PERMIT

SEWAGE DISPOSAL SYSTEM

MARYLAND STATE DEPARTMENT OF HEALTH*

ROAD AND DESCRIPTION 9432 Tiller Drive

9432 TILLER DR.
"MT. HEBRON"

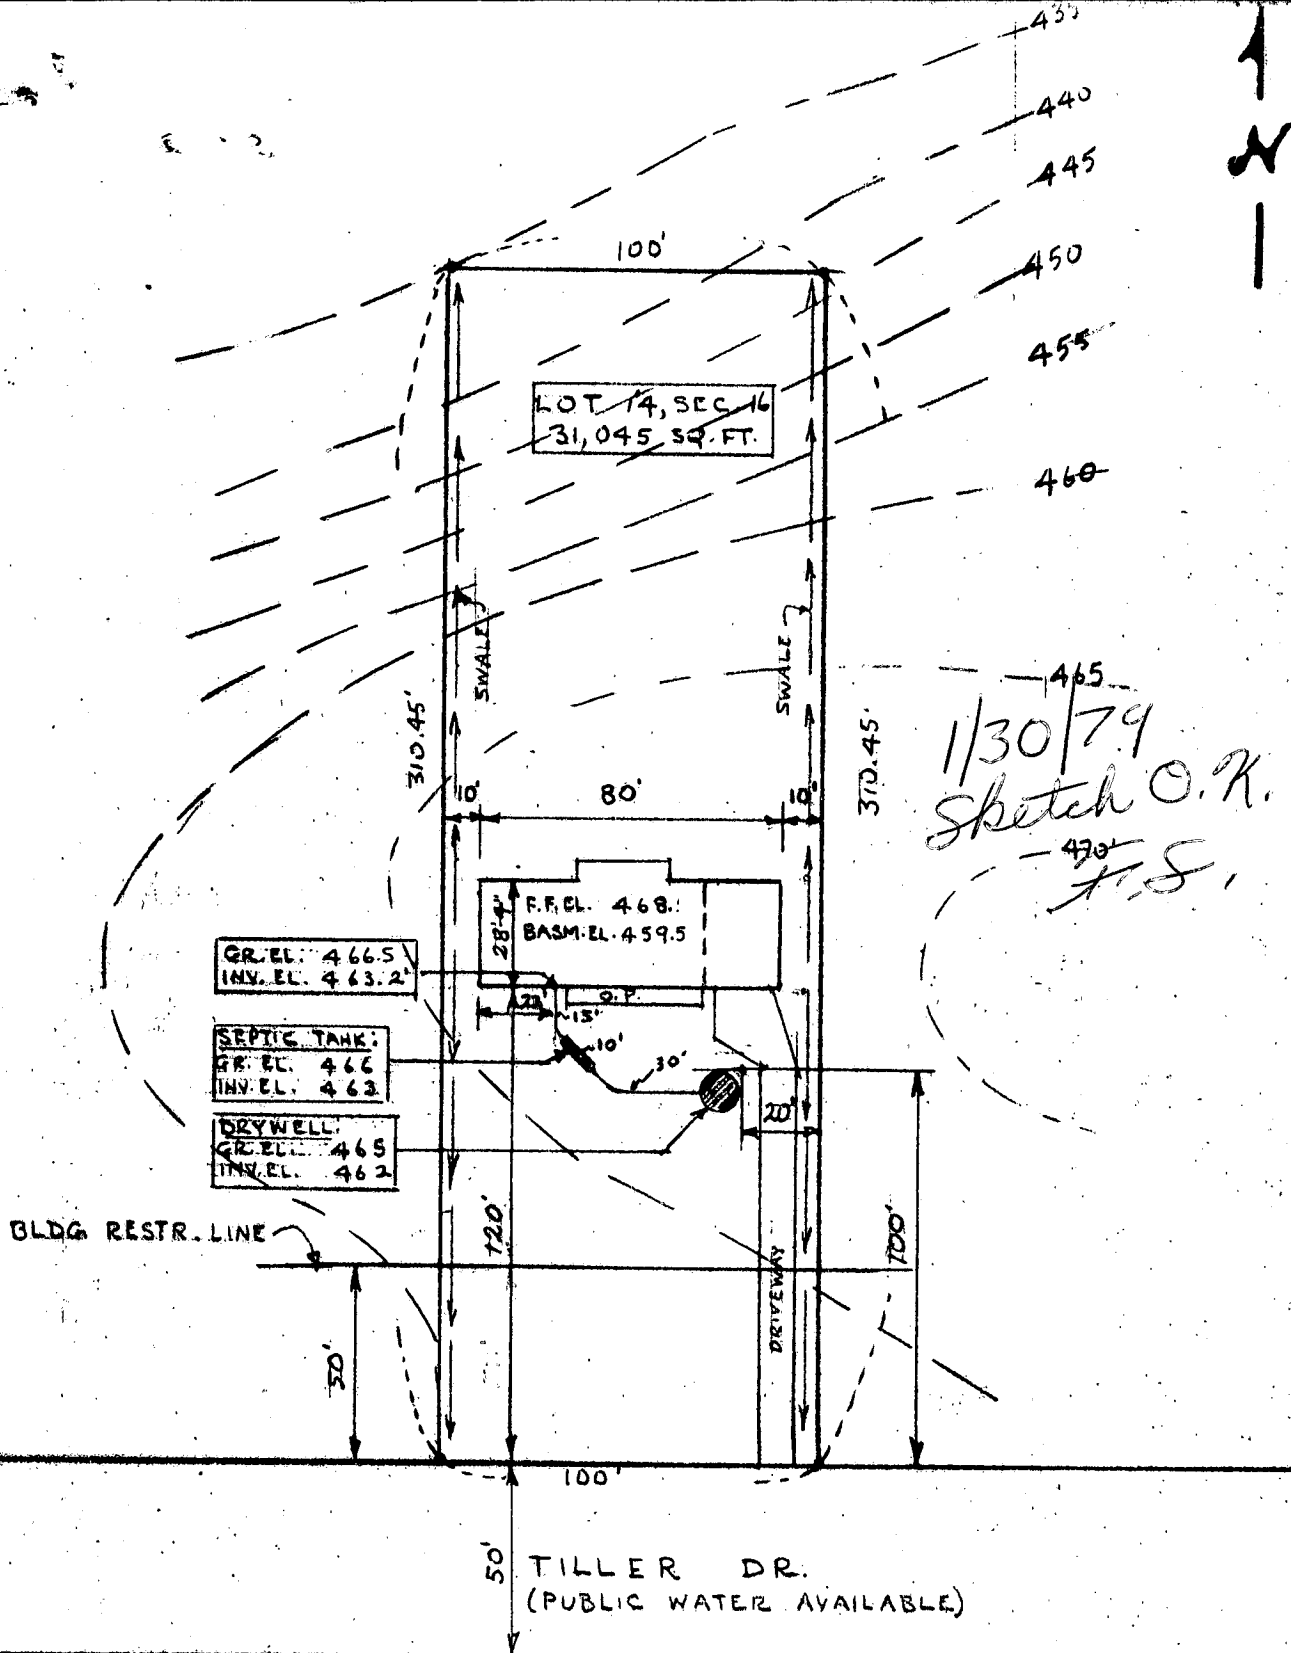
to have 140 SQ. FT. effective sidewall absorption area per bedroom to begin below the first 3 ft. of non-porous soil. Maximum depth permitted for drywell or trench is 10 ft. below original grade. Place the drywell ¹⁰⁰125 ft. from the front lot line and ²⁰25 ft. from the right side line as seen when facing the property from Tiller Drive.

APPROVED BY Frank Skinner FOR drywell (+ trench) DATE 12/13/78
 (KIND OF SYSTEM)

LOCATION SURVEY PLAT

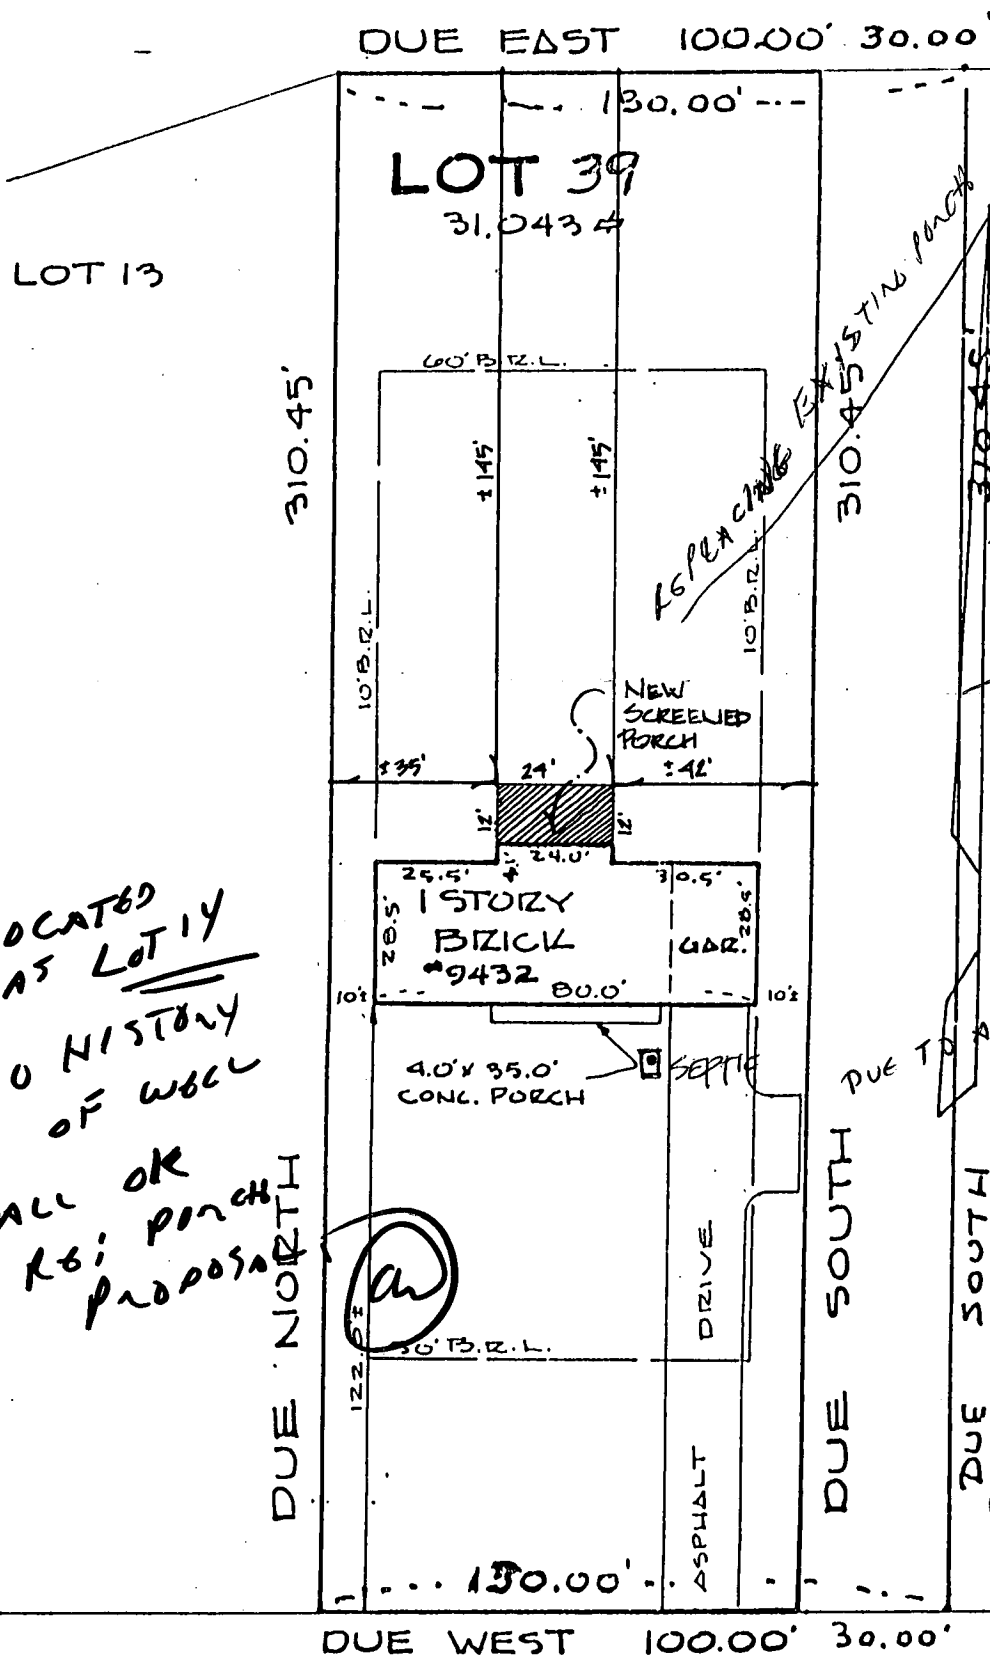
* LOCATED AS LOT 14
NO HISTORY OF WELL
ALL OK
RE: PORCH PROPOSAL

BOO105084
OK TO PROCEED
C. J. Hill
NO IMPACT TO SEPTIC
IS ON PUBLIC WATER AT THIS TIME,
BUT UNCLEAR IF PROPERTY WAS ORIGINALLY SERVED BY WELL OR NOT
AGE - WELL WOULD HAVE BEEN BELOW GRADE.
NO REASONABLE METHOD TO CONFIRM PROPER ABANDONMENT IF A WELL EVER EXISTED
(ONLY REASON FOR ALL THIS CONCERN IS THAT MOST PROBABLE LOCATION FOR WELL WOULD BE WHERE PORCH IS LOCATED)
